**SOLICITATION AMENDMENT
MODIFICATION DE L'INVITATION**

Title - Sujet CCG College: Roof Replacement	
Solicitation No. - N° de l'invitation EB144-151989/A	Amendment No. - N° modif. 002
Client Reference No. - N° de référence du client EB144-15-1989	Date 2015-03-02
GETS Reference No. - N° de référence de SEAG PW-\$PWA-121-5200	
File No. - N° de dossier PWA-4-72085 (121)	CCC No./N° CCC - FMS No./N° VME
Solicitation Closes - L'invitation prend fin at - à 02:00 PM on - le 2015-03-05	Time Zone Fuseau horaire Atlantic Standard Time AST
F.O.B. - F.A.B. Plant-Usine: <input type="checkbox"/> Destination: <input checked="" type="checkbox"/> Other-Autre: <input type="checkbox"/>	
Address Enquiries to: - Adresser toutes questions à: Russell (PWA), Alex	Buyer Id - Id de l'acheteur pwa121
Telephone No. - N° de téléphone (902) 496-5168 ()	FAX No. - N° de FAX (902) 496-5016
Destination - of Goods, Services, and Construction: Destination - des biens, services et construction:

Amendment 002 is raised for the following:

2.1 DRAWING S1.3 – STRUCTURAL REPAIR DETAILS SHEET 1 OF 2

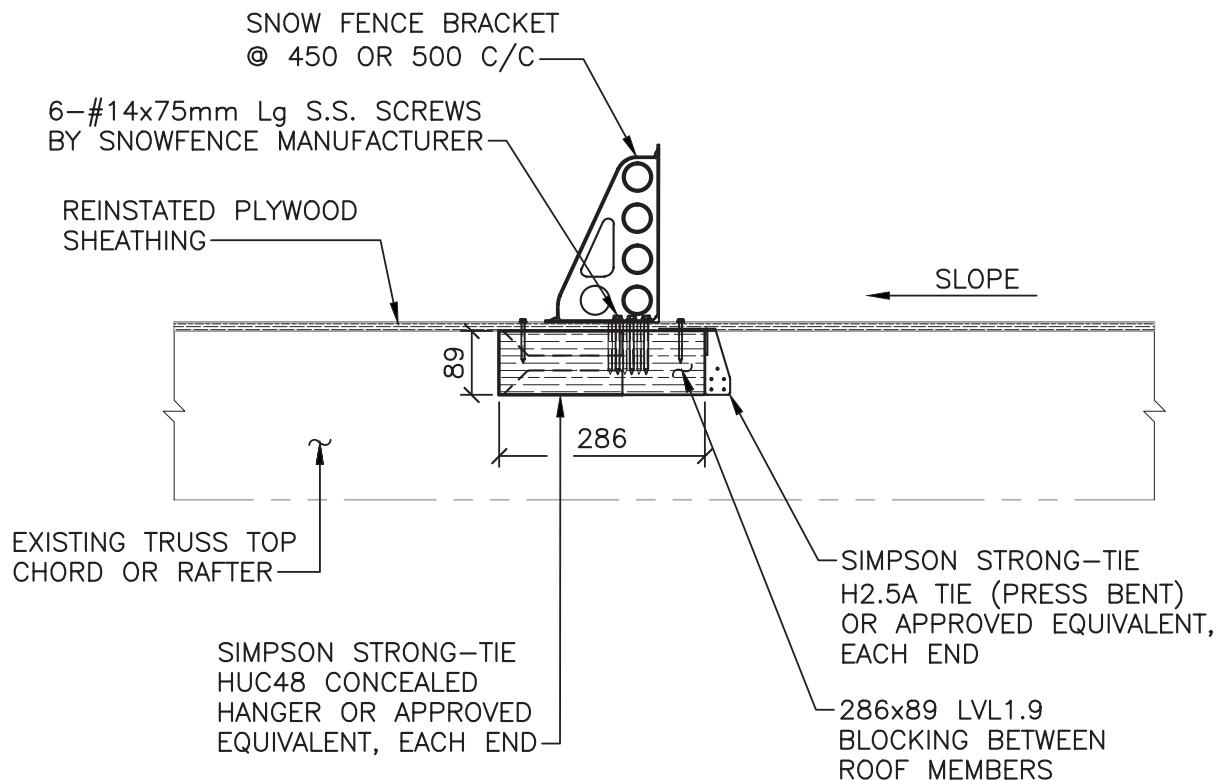
- .1 Add Structural Detail for snow fence support for timber framed buildings. See Structural Detail SK1.5 – SNOW FENCE SUPPORT TIMBER FRAMED BUILDINGS.

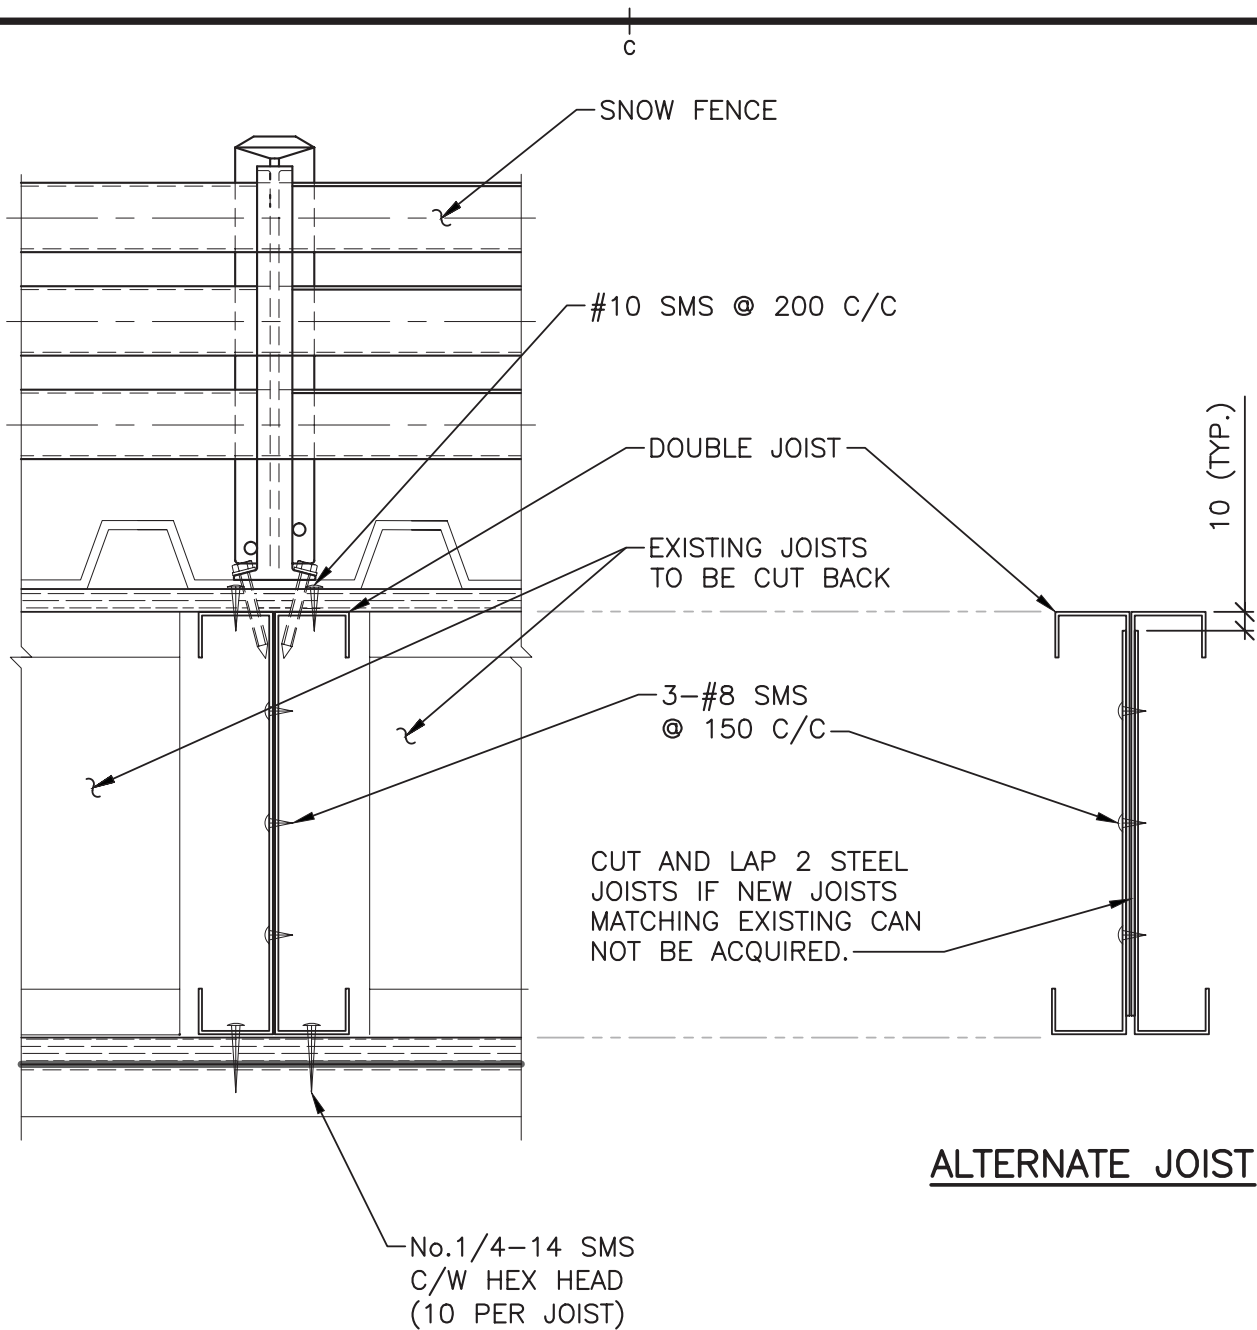
- .1 Add Structural Details for snow fence support for steel framed buildings. See Structural Details SK1.6 – SNOW FENCE SUPPORT METAL FRAMED BUILDINGS and SK1.7 – SNOW FENCE SECTION AND DETAILS.

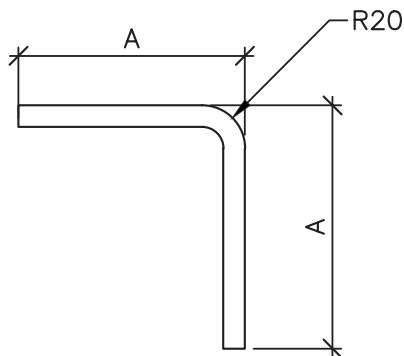
6. Question: Concerns regarding interior Cabot Building Structural repairs. Some beams and joist have interior partition walls or exterior load bearing walls under them, limiting space for welding bottom chord reinforcing, without removal of existing walls and services. Please confirm?
Answer: For W Section Reinforcing, contractor to do minimal removals of any interior wall that is underside of beam and use Alternate detail to 5A on Drawing S1.4 (See Structural Details SK1.8 and SK1.9 by attached Addendum #1.
